ISO/IEC
8802-11

AMENDMENT 4
2006-08-15

IEEE Std 802.11g-2003
(Amendment to
IEEE Std 802.11-1999)

AMENDMENT 4: Further Higher Data Rate Extension in the 2.4 GHz Band

Figure 27—Capability Information fixed field

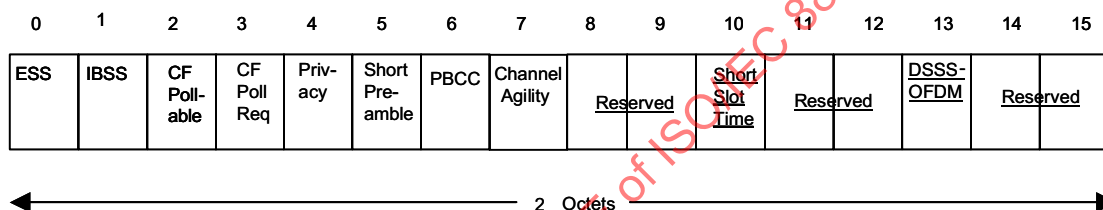
Replace Figure 27 with the following:

The length of the Capability Information field is 2 octets. The Capability Information field consists of the following subfields: ESS, IBSS, CF-Pollable, CF-Poll Request, Privacy, Short Preamble, Packet Binary Convolutional Code (PBCC), and Channel Agility, Short Slot Time, and DSSS-OFDM. The format of the Capability Information field is illustrated in Figure 27. No subfield is supplied for ERP as a STA supports ERP operation if it includes all of the Clause 19 mandatory rates in its supported rate set.
